Historic District Board of Review
Office of Planning and Preservation
City of Madison, IN

Meeting: 06/22/2020

COA STAFF REPORT

Site Plan

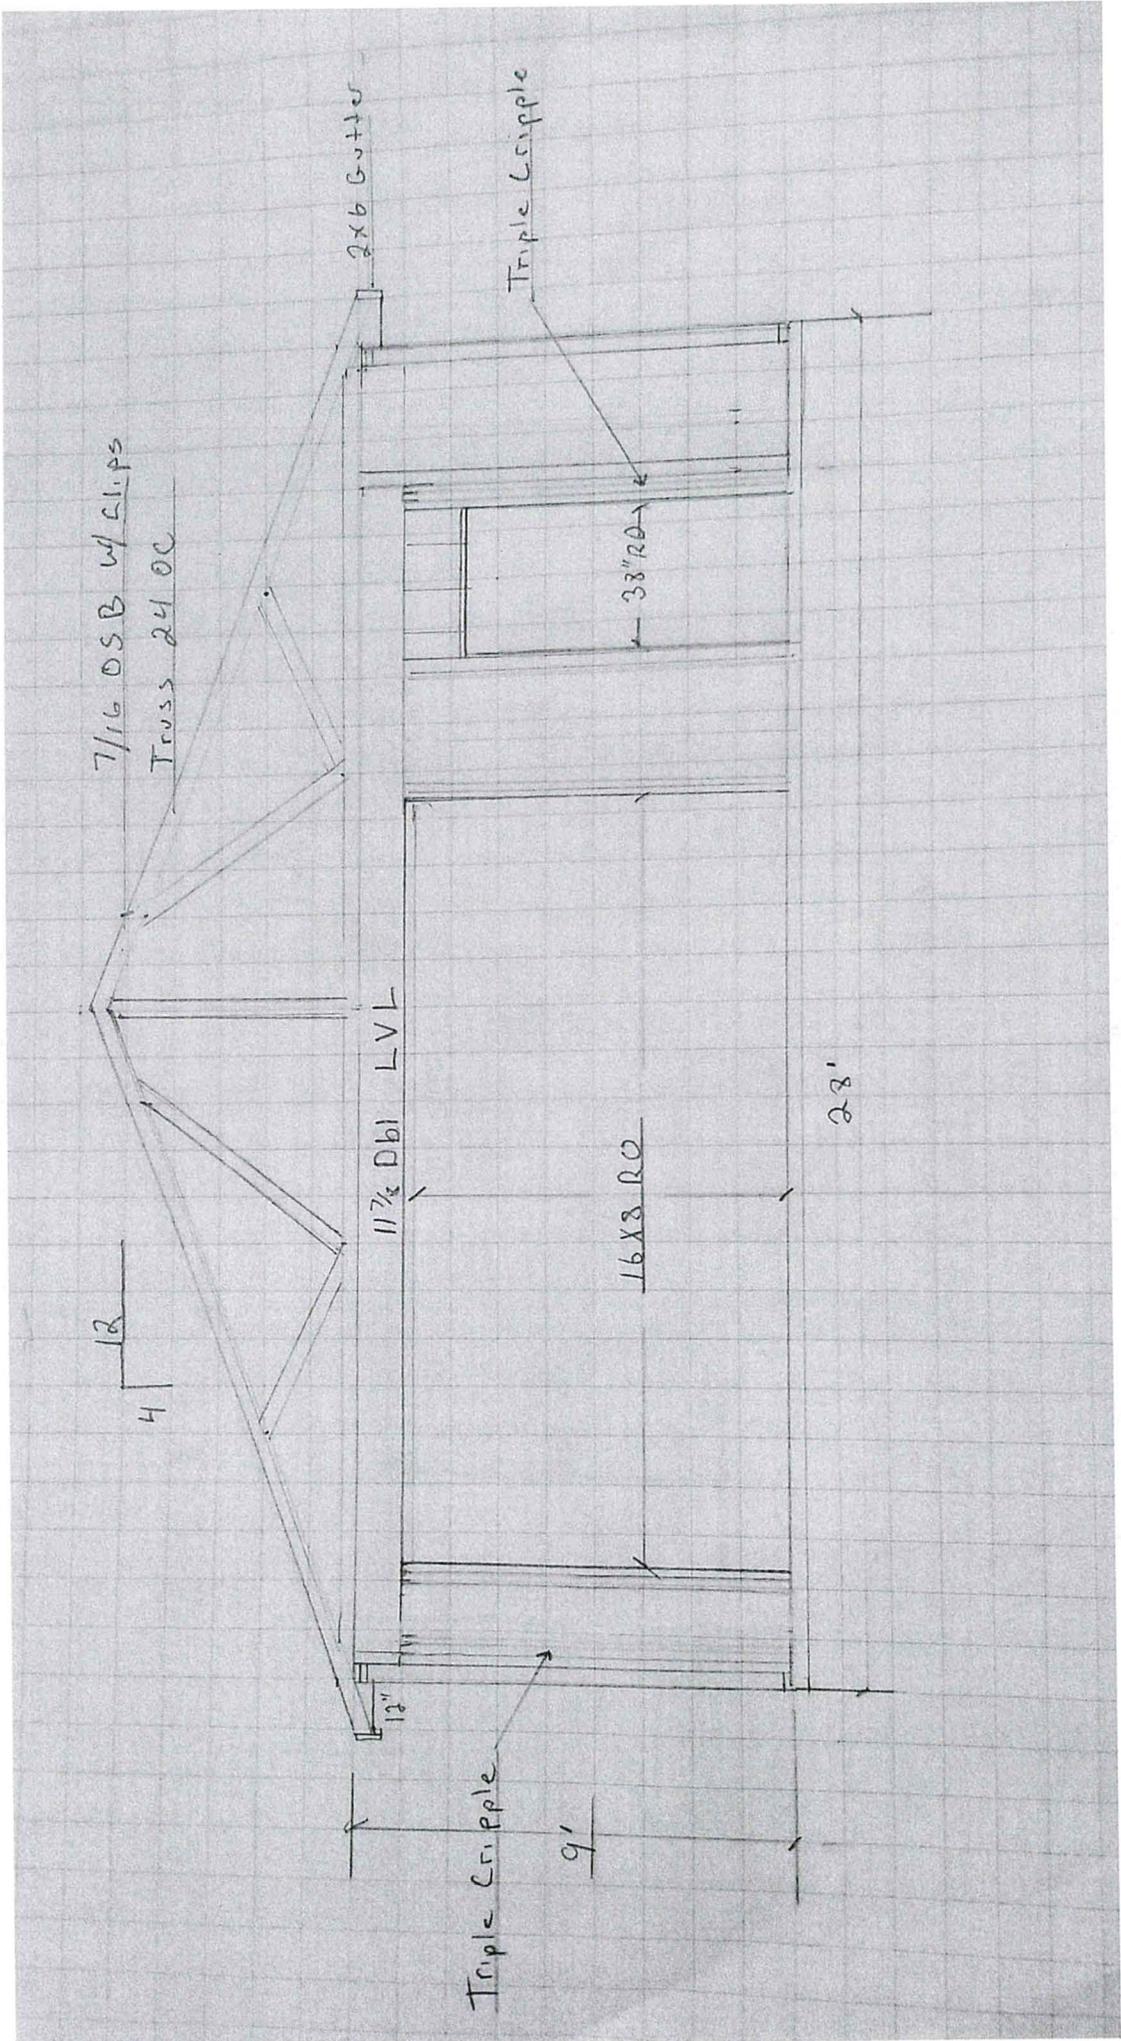
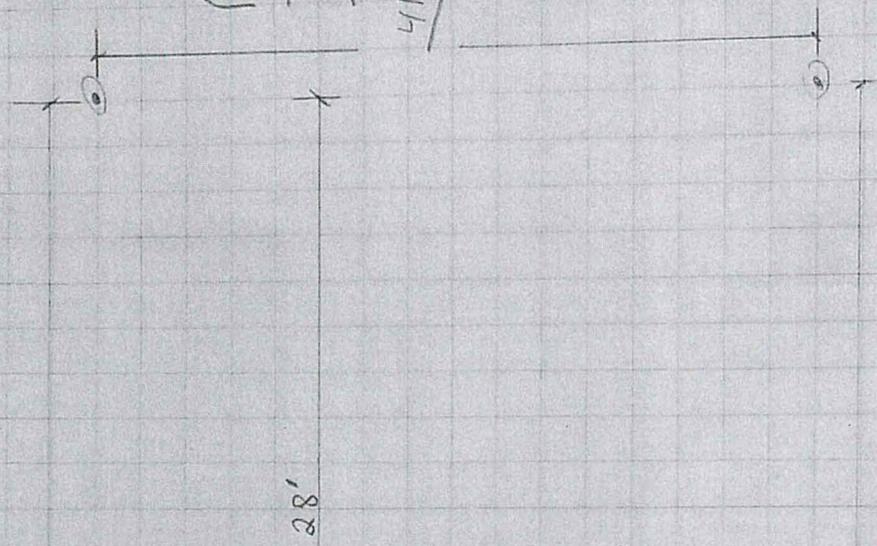
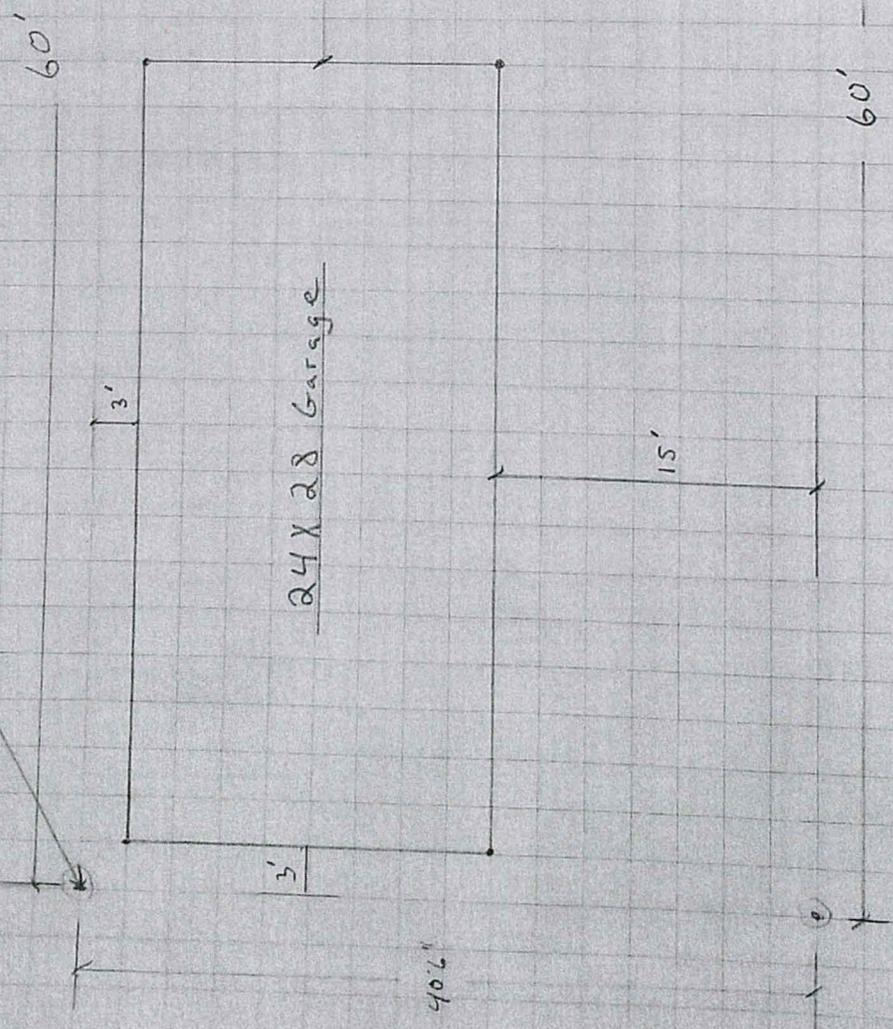
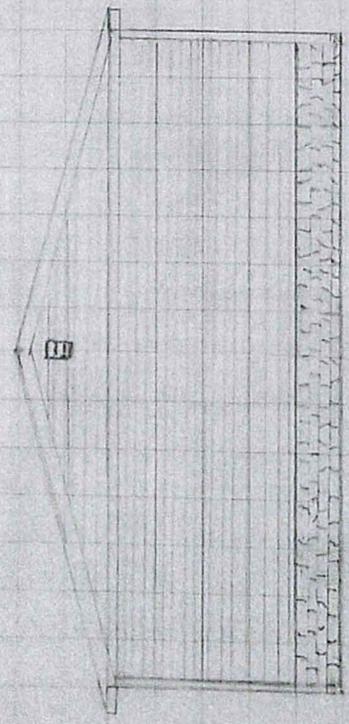
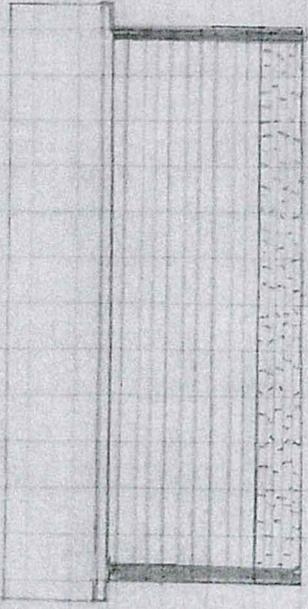
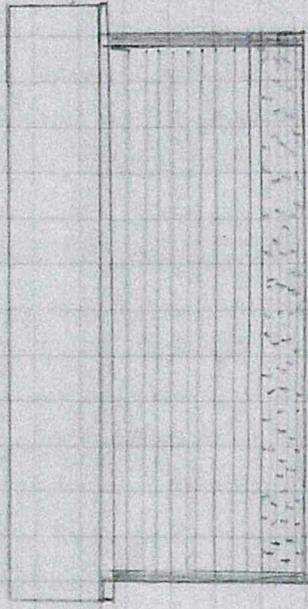
It is staff's opinion that the project is in conformance with the design guidelines. There is no dwelling on this site. There are carriage houses set on their own properties throughout downtown. Building will be compatible in terms of height, setback, materials, and form.
